Reliability Analysis Update

Transmission Expansion Advisory Committee

July 7, 2026

2026 RTEP Window 1 Update

Baseline Scope / Cost Changes

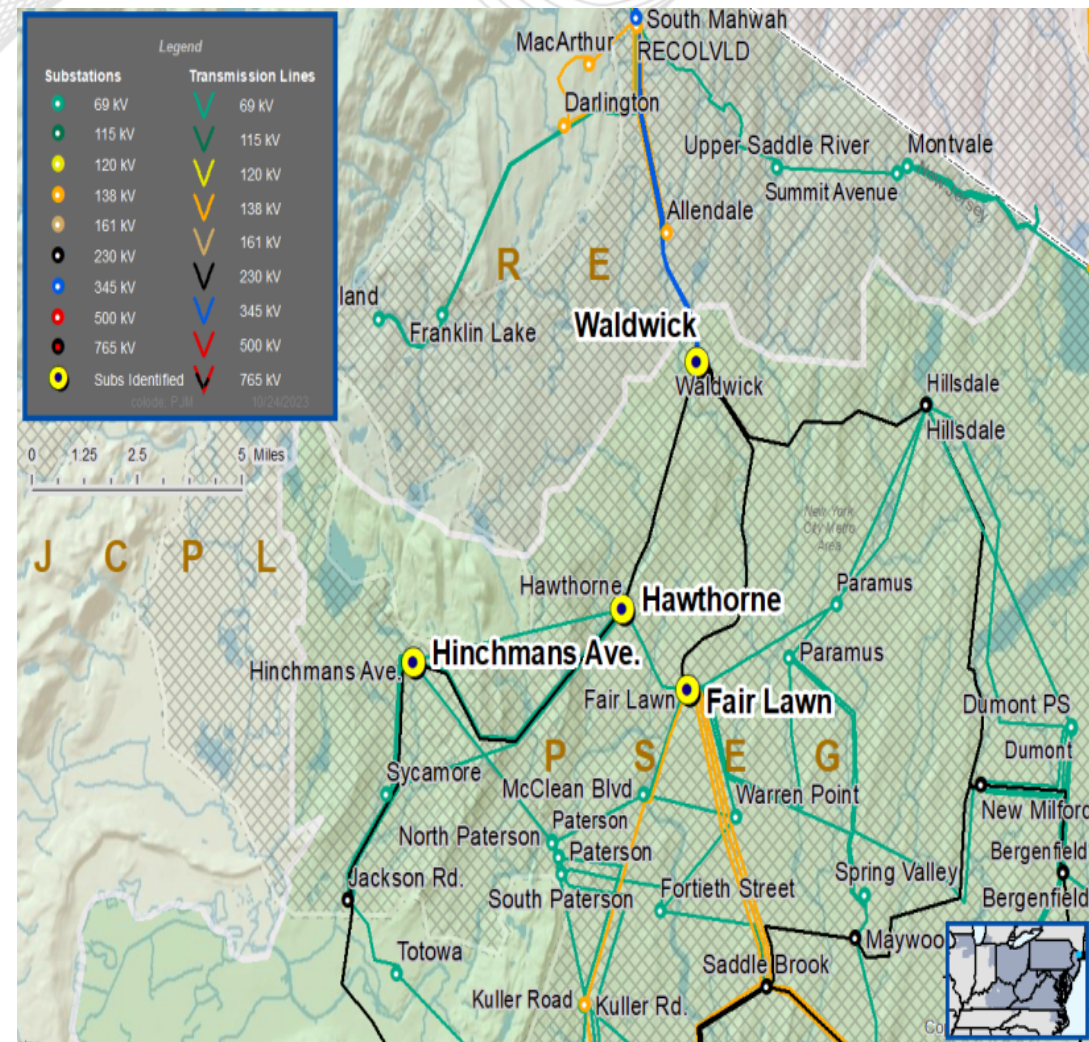
Problem Statement: High voltage issue on multiple stations around Waldwick vicinity for several contingencies.

Replace existing 230kV 50MVAR fixed shunt reactor with a 230kV 150MVAR variable shunt reactor. **(B3794.1) Estimated Cost: \$13.6M-\$21.9M**

Replace existing 345kV 100MVAR fixed shunt reactor with a 345kV 150MVAR variable shunt reactor. **(B3794.2) Estimated Cost: \$16.0M-\$23.5M**

Reason for Cost Increase:

- Equipment costs have increased since the project was proposed and approved. Tariffs have added to equipment costs as well.
- A recent uptick of reactor failures has resulted in PSE&G modifying its standards for switching methods for reactors going forward. New reactor breakers with “point on wave” switching capability provide a safer and more reliable method to switch the reactors while helping to preserve the lifespan of the reactors. The original scope did not include replacement of reactor breakers.

Estimated Total Cost: \$29.6M-\$45.4M

Approved Targeted Market Efficiency Project (TMEP) b2971: Burnham – Munster 345kV (ComEd-NIPS)

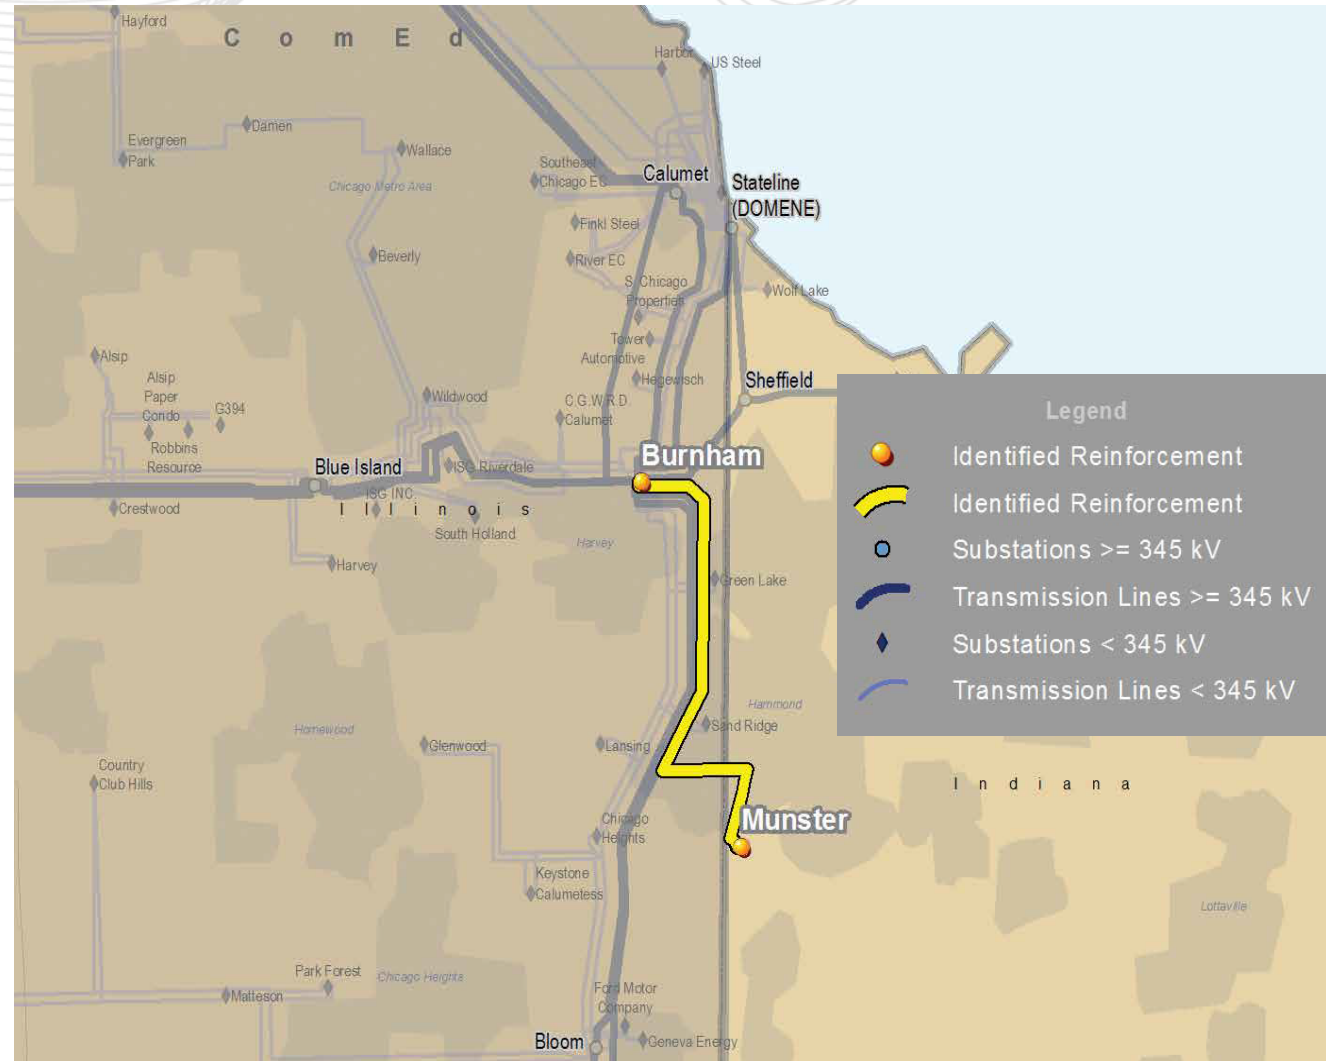
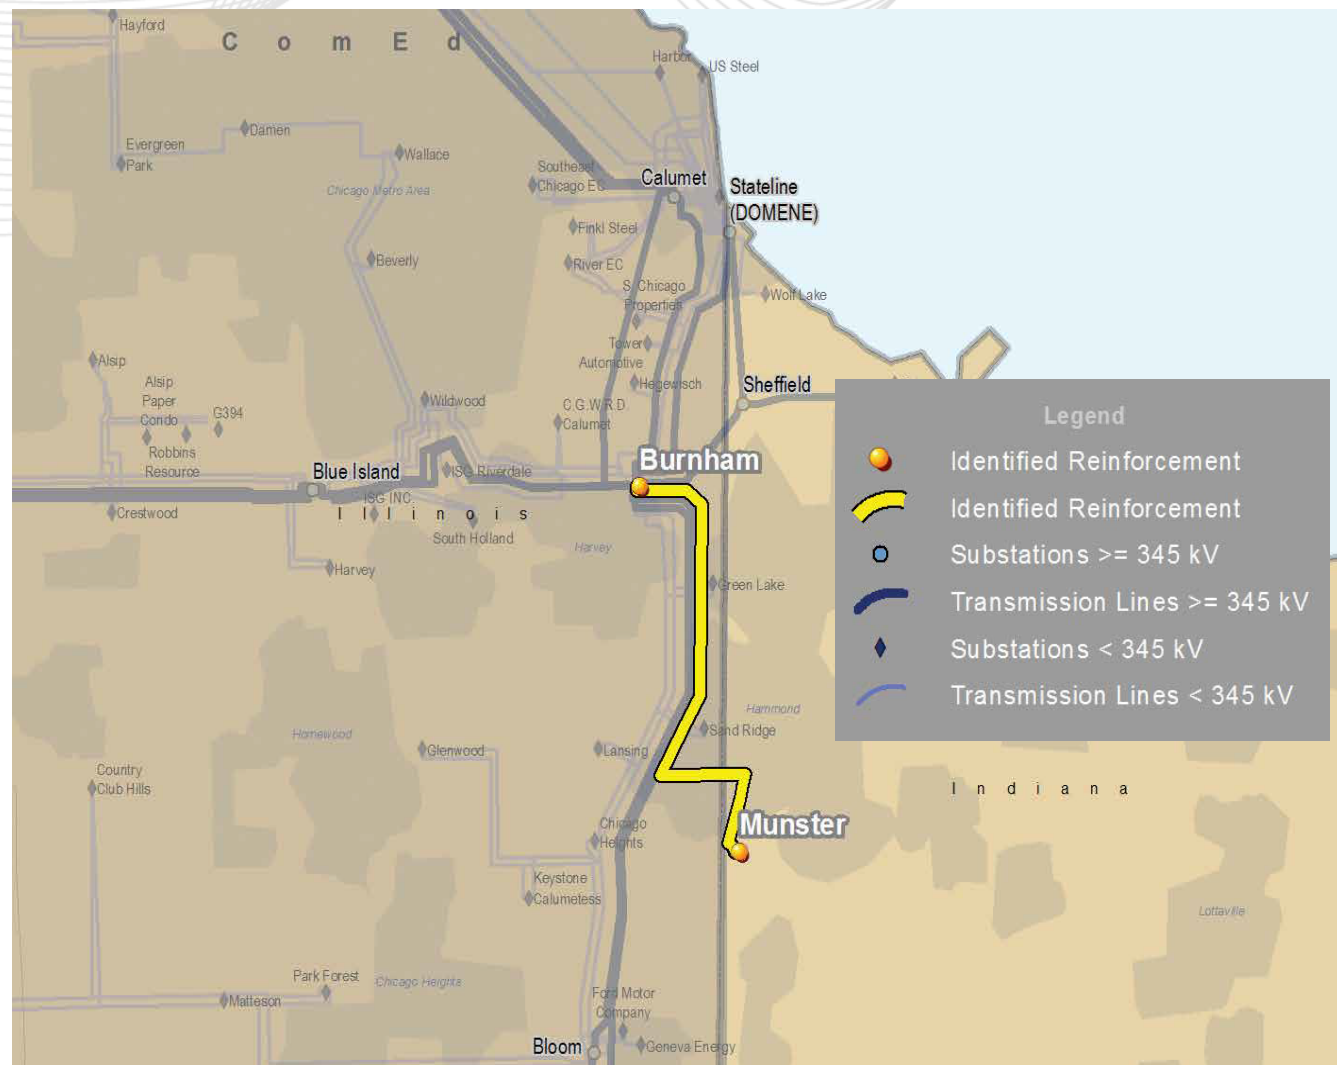
Rationale for Scope Change:

TMEP b2971 project to reconfigure Munster 345 kV as a ring bus that was assigned to NIPSCO was previously presented to TEAC on November 9, 2017, and approved by the PJM Board in December 2017.

PJM previously identified that a portion of the scope of the b2971 project would include sag mitigation on the ComEd portion of the line from Burnham to Munster, as a sub-project b2971.1 with a cost estimate of \$500,000. However, the b2971.1 project was not presented to TEAC or submitted for approval by the PJM Board, although it was still assigned to ComEd for completion as part of the b2971 project being performed by NIPSCO.

Ultimately, the b2971.1 sag mitigation sub-project was completed and placed in-service by ComEd on November 4, 2019, while the parent project b2971 was completed and placed in-service by NIPSCO on December 18, 2019.

This scope change is being presented to the TEAC to formally introduce the scope change and to request approval by the PJM Board in July 2026 to ensure the appropriate cost allocation for this portion of the b2971 project.

TMEP b2971.1 Project Description (Scope Change):

- *Scope:* Perform sag mitigation on the Burnham-Munster 345 kV circuit
- *Required ISD:* 6/1/2020
- *Actual ISD:* 11/4/2019
- *TMEP Cost Estimate:* \$500,000
- *Actual Cost:* \$500,000
- *Interregional Cost Split:* 88% PJM / 12% MISO
